WORCESTER COUNTY PLANNING COMMISSION AGENDA

Thursday, February 5, 2026

A. Major Site Plan Review – Bishopville Volunteer Fire Department

Re: Bishopville Volunteer Fire Department Major Site Plan Review

**DEMOLITION
PLAN**

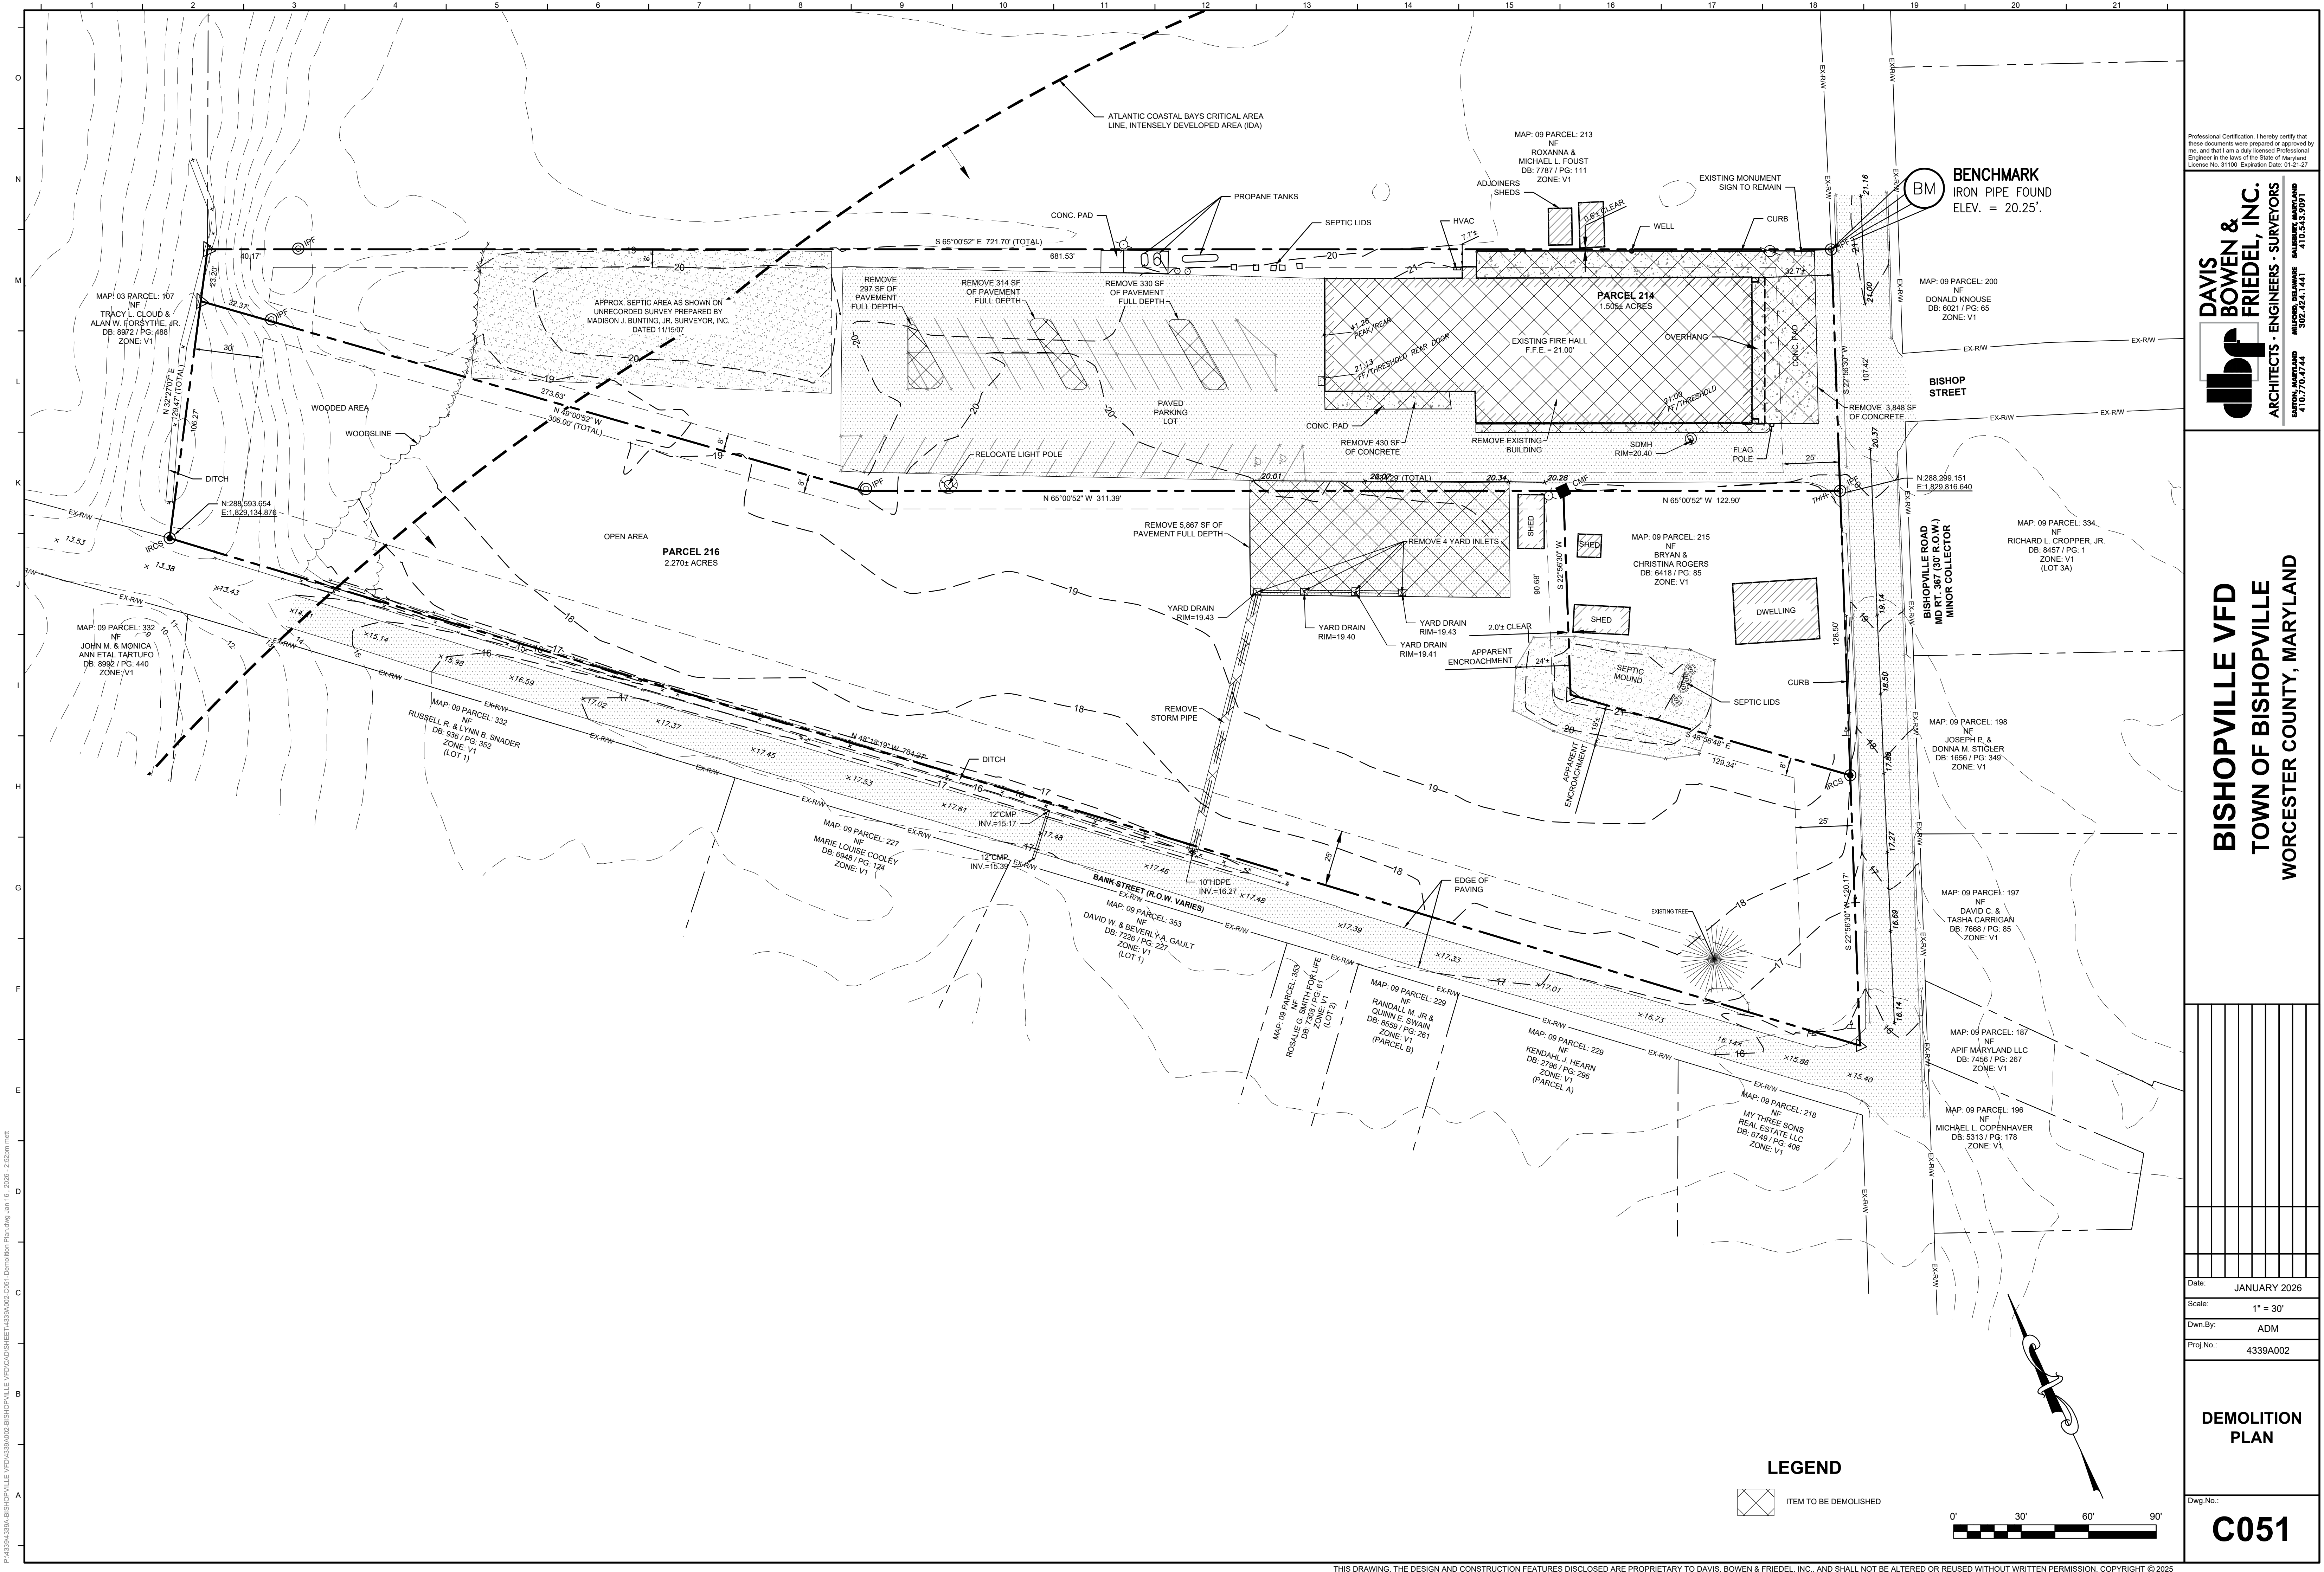
1. Sheet C101: Please add the monument signage and label that is to remain on the site.
2. Sheet C101: Please confirm that the curbing for the parking spaces will be at least three feet away from the landscaping features to prevent damage as outlined in §ZS 1-320(f)(5).
3. Sheet L101: Please add a note that an automatic irrigation system will be installed for the landscape maintenance per §ZS 1-322(b)(7).
